Access Compliance Report

Public Rights-of-Way

Intersection ID: 28402	Main Street: HAWFIELD_WAY_DR	Cross Street: LANCASTER_HY	Location: NE
ADA ID: 740089518E1E	Ramp Type: BlendTrans2	Initial Pass/Fail: Fail	Overall Compliance: No
		Severity Score: 1.25

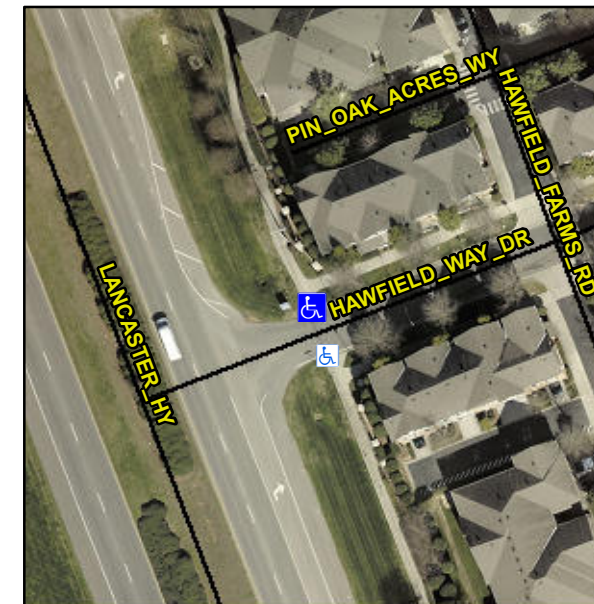
Not Found, R304.5.3

Compliance	Description	Data	Compliance	Description	Data
N/A	Ramp Length (in)	96.0	Yes	BlendTrans Slope (%)	3.7
Yes	Ramp Width (in)	48.0	No	BlendTrans XSlope (%)	3.9
N/A	Flare Type LT	N/A	N/A	Flare Type RT	N/A
N/A	Flare Slope LT (%)	N/A	N/A	Flare Slope RT (%)	N/A
N/A	Flare Traversable LT?	N/A	N/A	Flare Traversable RT?	N/A
N/A	Landing Length (in)	N/A	N/A	DWS Provided?	N/A
N/A	Landing Width (in)	N/A	N/A	DWS Contrast?	N/A
N/A	Landing Slope (%)	N/A	N/A	DWS Length (in)	N/A
N/A	Landing X Slope (%)	N/A	N/A	DWS Full Width?	N/A
N/A	Landing Curb? (Y/N)	N/A	N/A	DWS Offset (in)	N/A
N/A	Shared Landing?	N/A			
N/A	Gutter Ponding?	N/A	N/A	Gutter Slope (%)	N/A
N/A	Gutter Lip Ht (in)	N/A	N/A	Gutter X Slope (%)	N/A
N/A	Painted X Walk1?	No	N/A	Painted X Walk2?	N/A
	X Walk 1 Direction	To SE		X Walk 2 Direction	N/A
	X Walk 1 Width (in)	N/A		X Walk 2 Width (in)	N/A
	X Walk 1 Slope (%)	0.3		X Walk 2 Slope (%)	N/A
	X Walk 1 X Slope (%)	3.5		X Walk 2 X Slope (%)	N/A

N/A	Ramp inside XWalk1?	N/A	N/A	Ramp inside XWalk2?	N/A
	Road Slope (%)	3.5		Clear Space?	N/A
	Road X Slope (%)	0.3	N/A	Clear Space to XWalk (in)	N/A
N/A	Any Obstructions?	N/A	N/A	Storm Grate/Utility Hazard?	N/A
	Obstruction Type			Storm Grate/Utility Type	
		N/A			N/A
			Yes	Surface Condition? (G/P)	Good
			No	Curb Slope (%)	12.7

Remove & Replace Curb Ramp With Two New Directional Ramps or Equivalent.
